STATE OF NORTH CAROLINA
DEPARTMENT OF TRANSPORTATION

Subject: **Application for Modification of the Section 404 Individual Permit, Section 401 Water Quality Certification, and Riparian Buffer Certification** for the Continuation of Greensboro-High Point Road (SR 4121) on New Location in Guilford County, Federal Aid Project No. STP-4121(1), Division 7, TIP No. U-2412 A, Debit \$570 from WBS 34802.1.1.

**Minutes from the Interagency 4C Permit Drawing Review Meeting
U-2412A in Guilford County
September 21, 2017
NCDOT Century Center
10:00 AM – 12:00 PM**

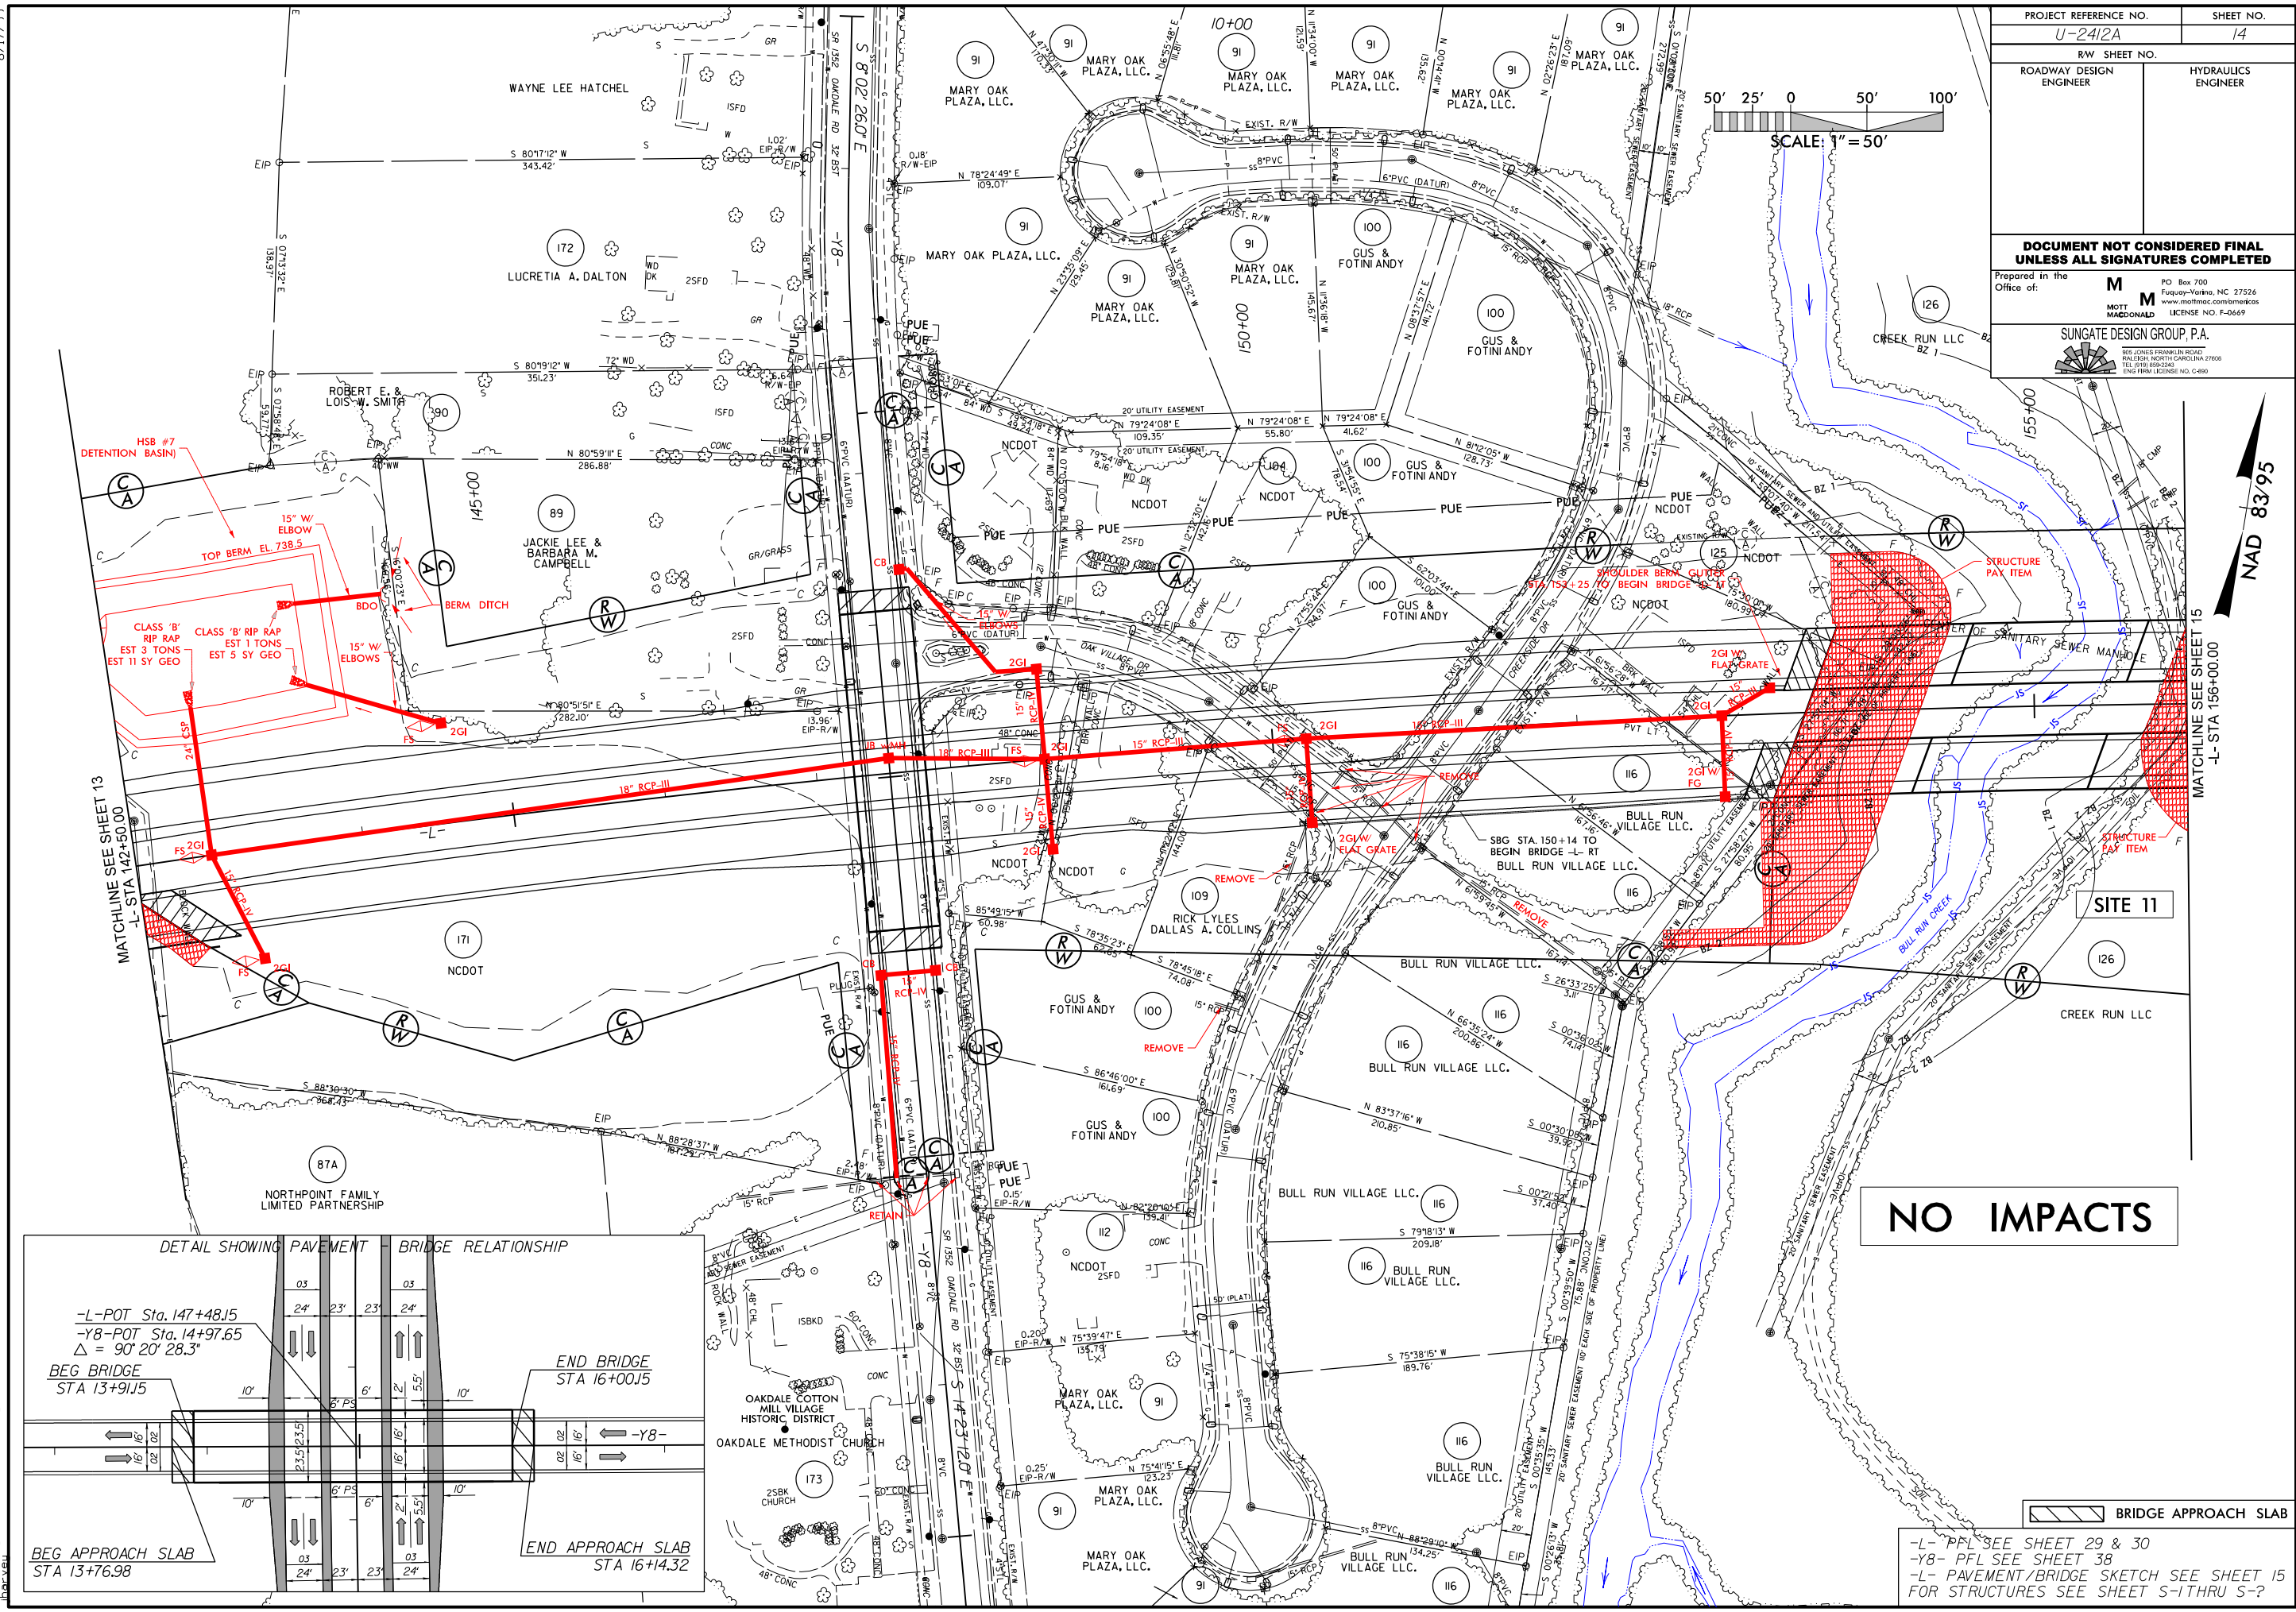
Site 11 (Plan Sheet 14):

- No Comments.
- The structural design of the bridge is currently in progress. The span arrangement and bent locations may change during the design; however, no bents will be located in the stream. Any temporary impact necessary for bridge construction will be verified prior to submitting the permit application to avoid a permit modification.

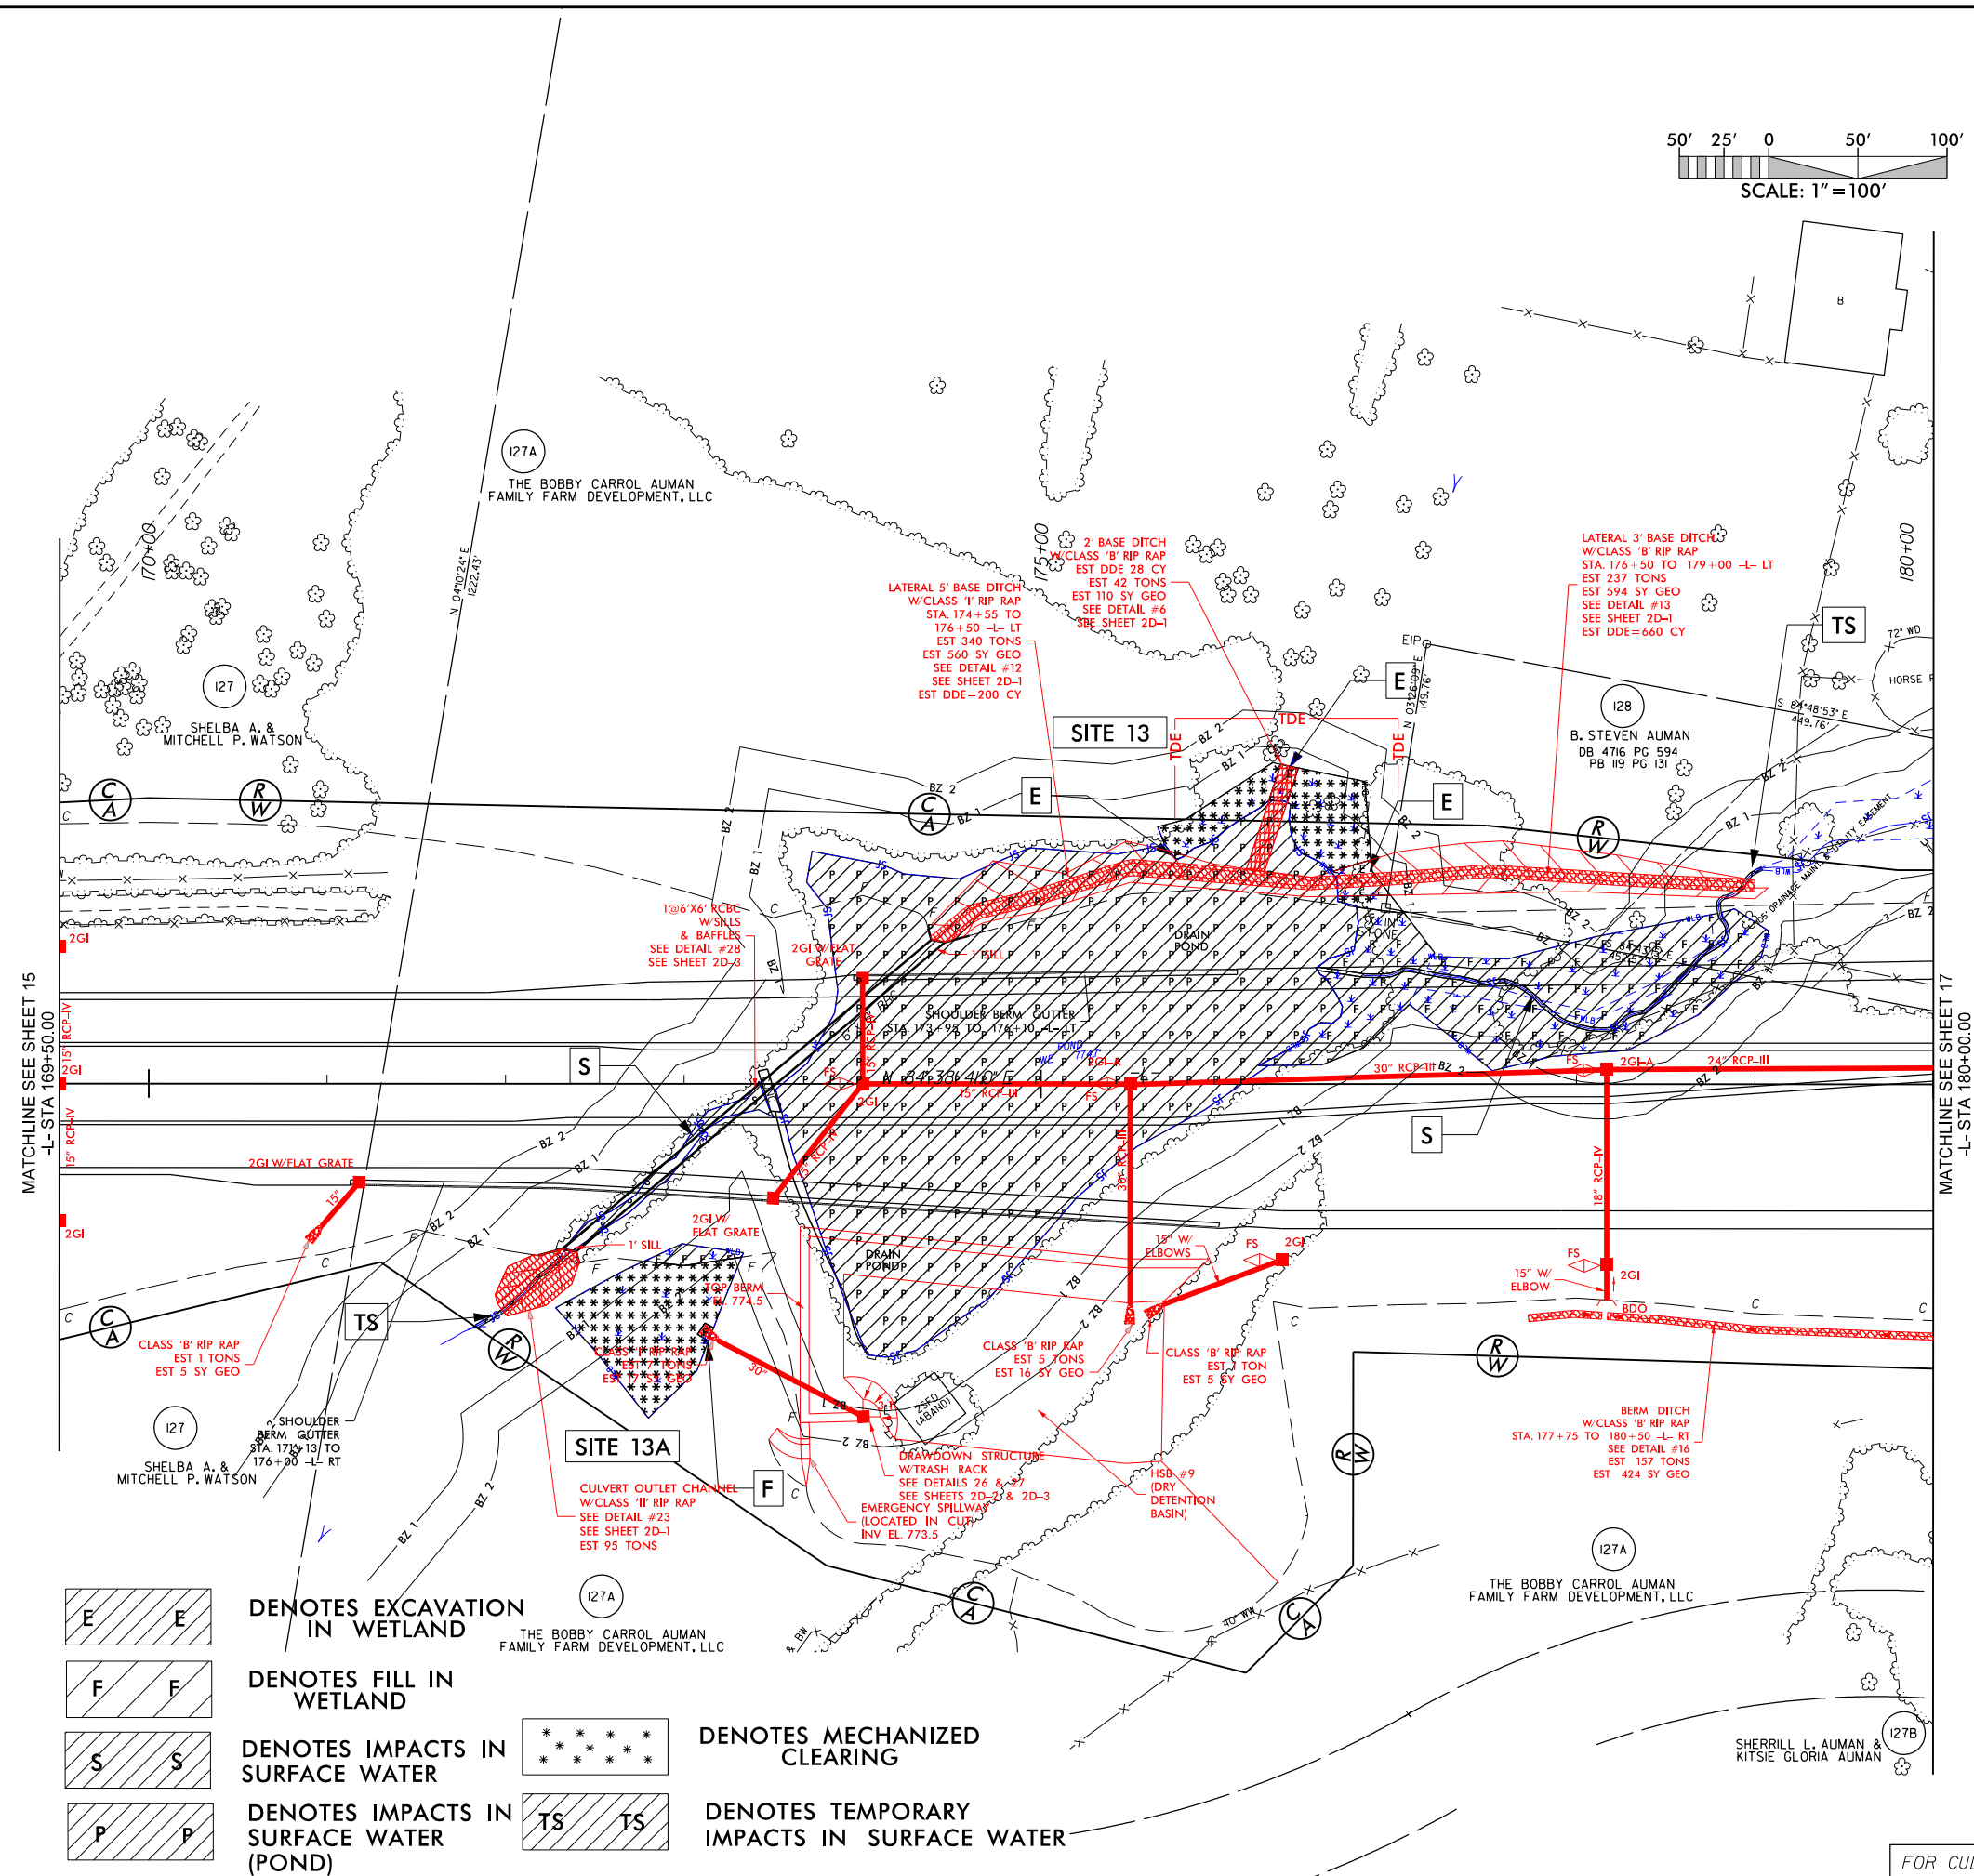
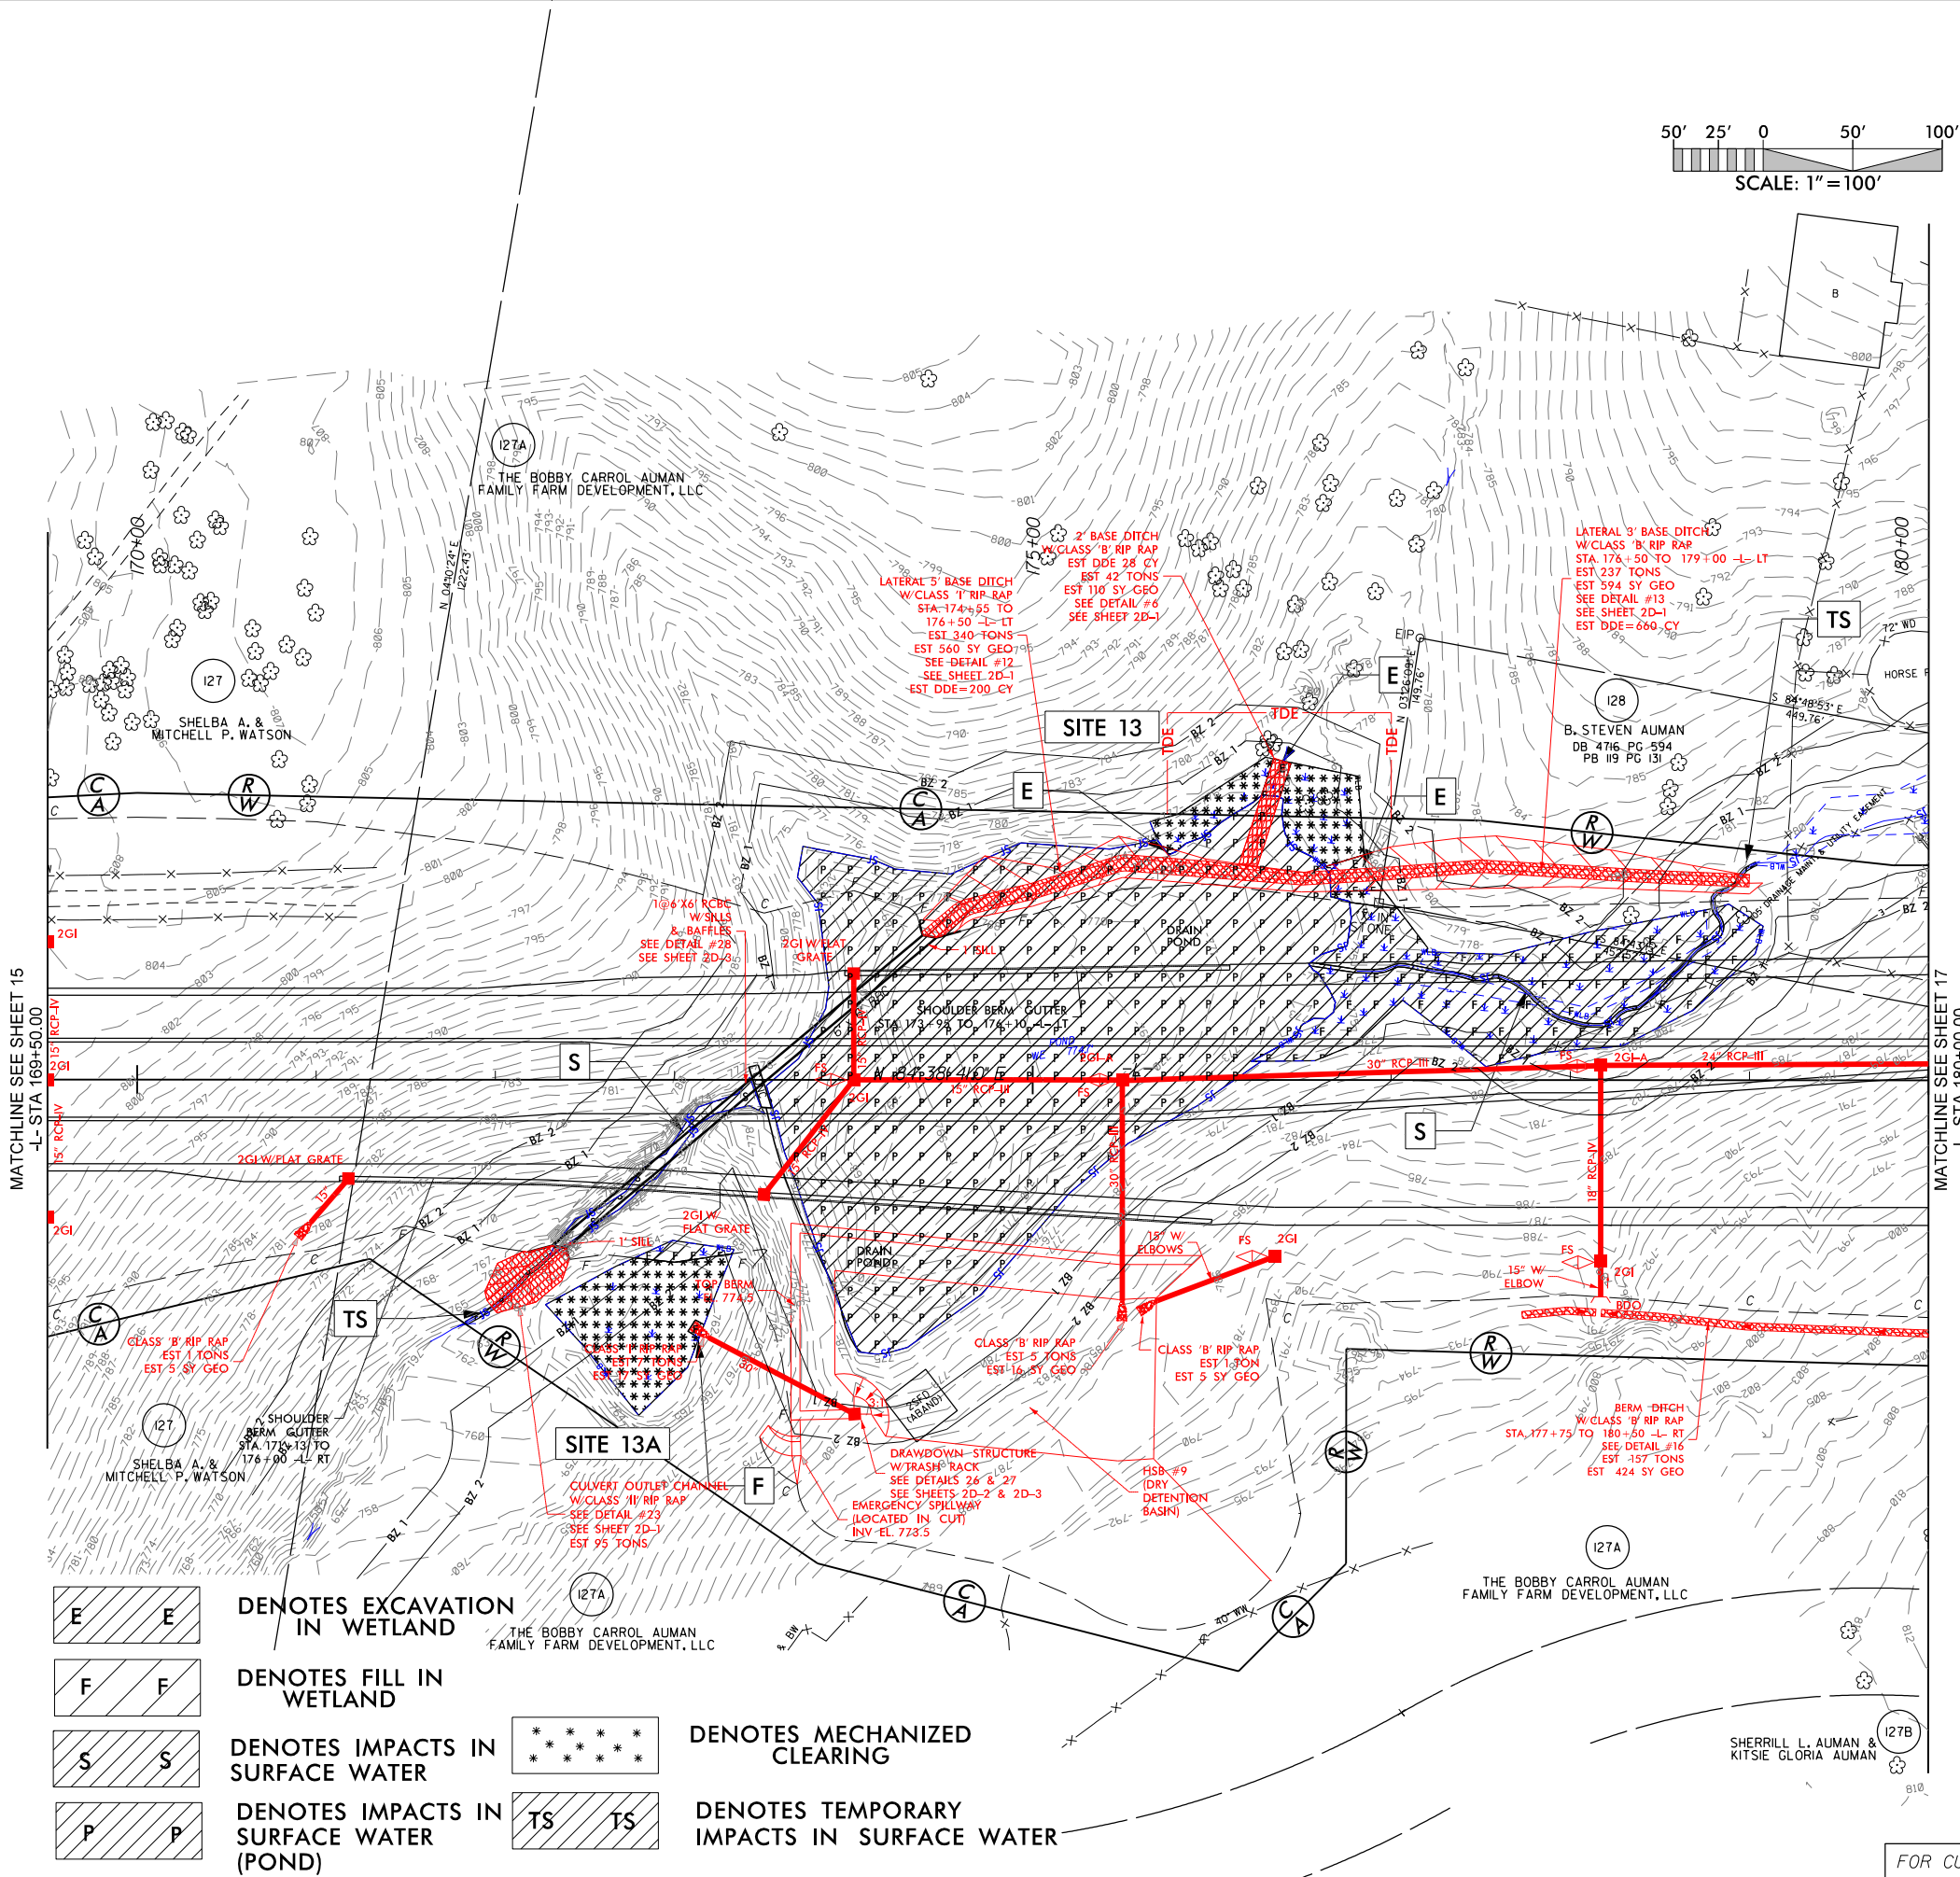
Site 13 (Plan Sheet 16):

- There is a separate wetland located near the outlet of the box culvert. Add Site 13A and include impacts separately in the summary.
